# CITY OF ST. HELENS PLANNING DEPARTMENT STAFF REPORT

Variance V.1.21

164 S. 1st Street

Variance to allow a reduced front yard (setback)

Date: 03 December 2020 To: City Planner

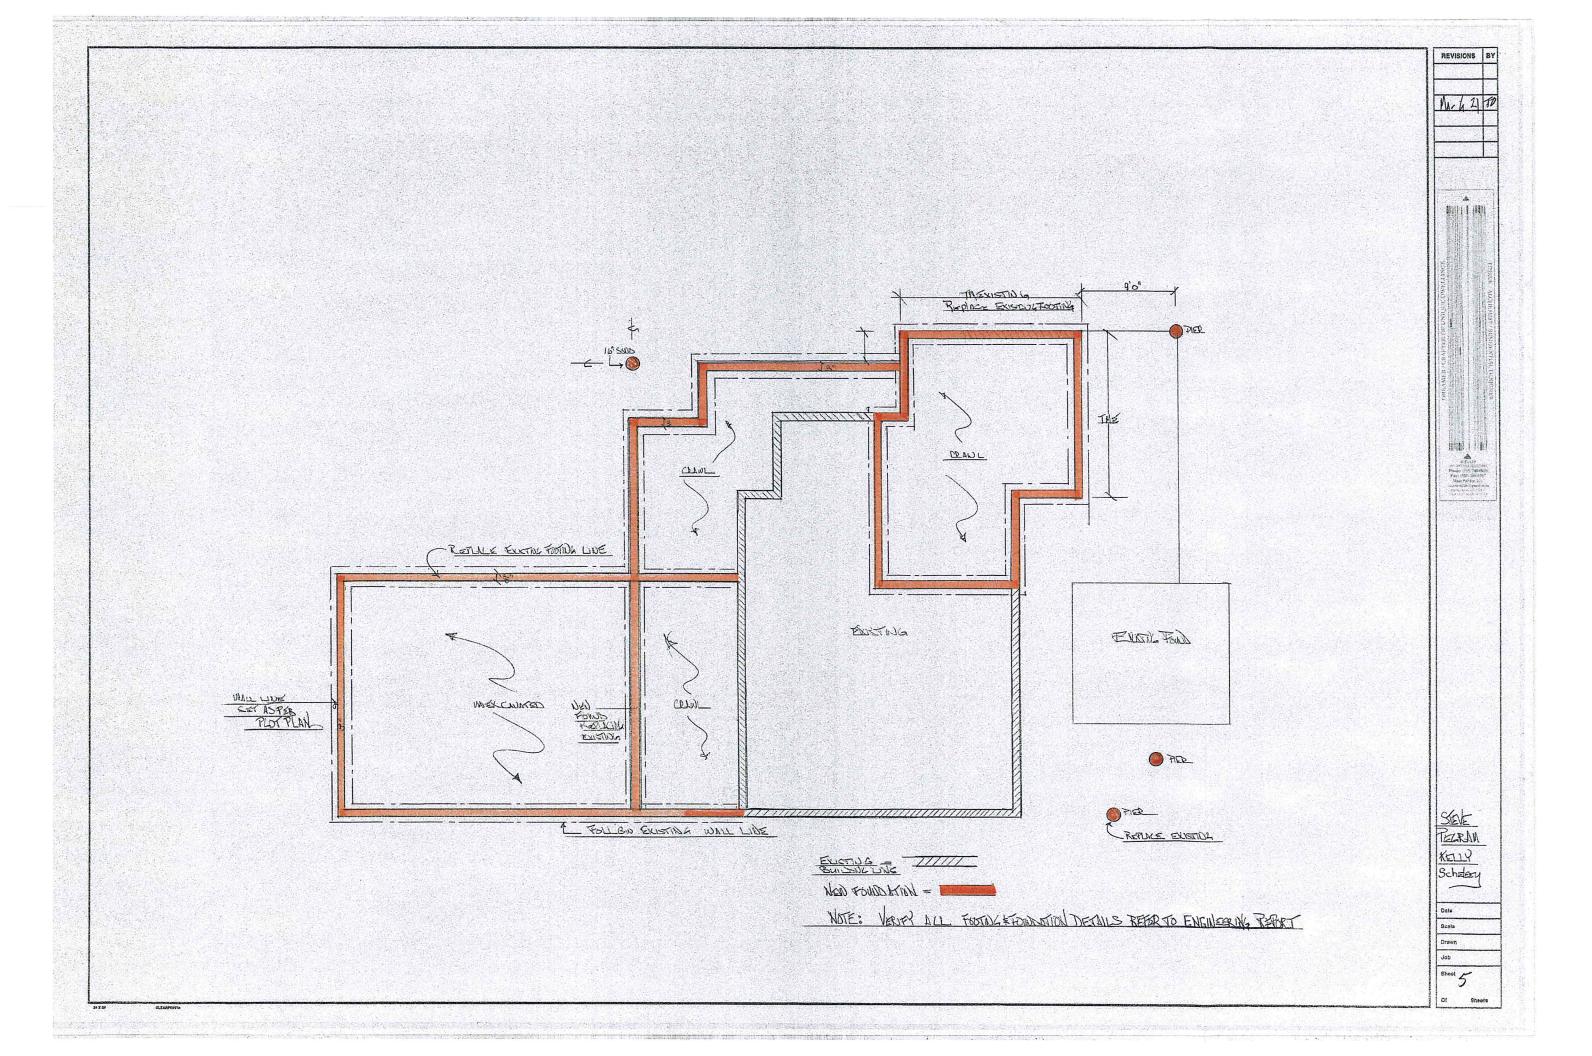
The site plan shows a new eave along the northern property line about 2.5 feet from the property line. The applicant has stated that this eave is intended be at least 3 feet from the property line. If the new eave is less than 3 feet from the property line, a separate variance is required. The

- 1. This Variance approval is valid for a limited time pursuant to SHMC 17.108.040.
- 2. The new eave along the north property line is to be at least 3 feet from the property line, not 2.5 feet as shown on the site plan. An eave less than 3 feet from the property line will require a separate Variance and approval from the Building Department.
- 3. Owner/applicant and their successors are still responsible to comply with the City Development Code (SHMC Title 17), except for the Variance(s) granted herein.
